TECHNICAL BULLETIN

LTB00762NAS1

Door Pad / Quarter Trim Panel Insert 'Water Tideline' Evident

Range Rover Evoque (LV)

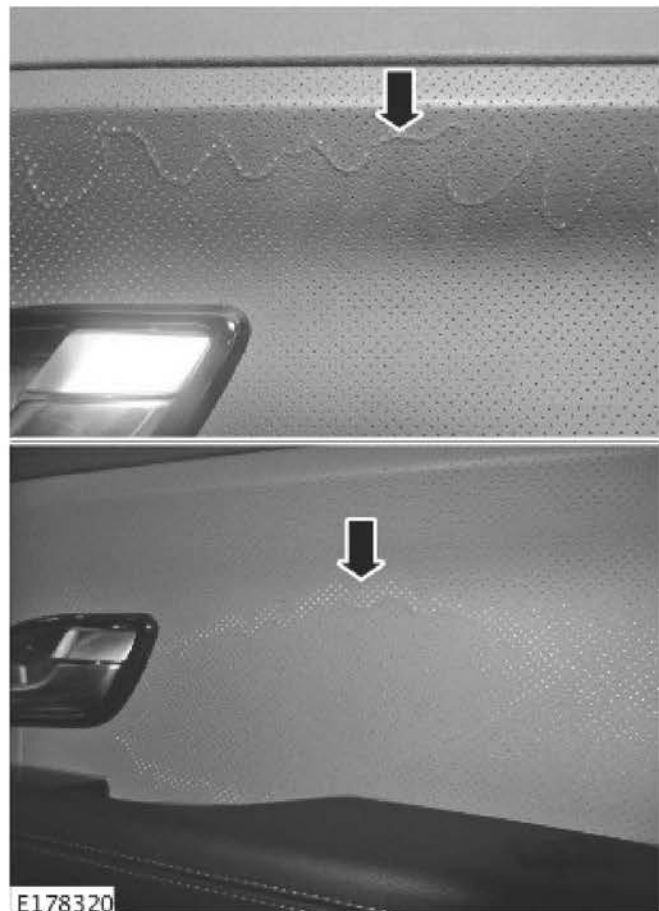
Situation: The perforated leather door pad(s) and/or rear quarter trim panel insert(s) (Coupe only) may exhibit a 'water tideline'.

Cause: This may be caused by water entering the door pad insert via the open pores in the perforations of the leather.

1 Check for evidence of a 'water tideline'.

Install a new front door trim panel, (see TOPIx Workshop Manual section 501-05: Interior Trim and Ornamentation - Front Door Trim Panel).
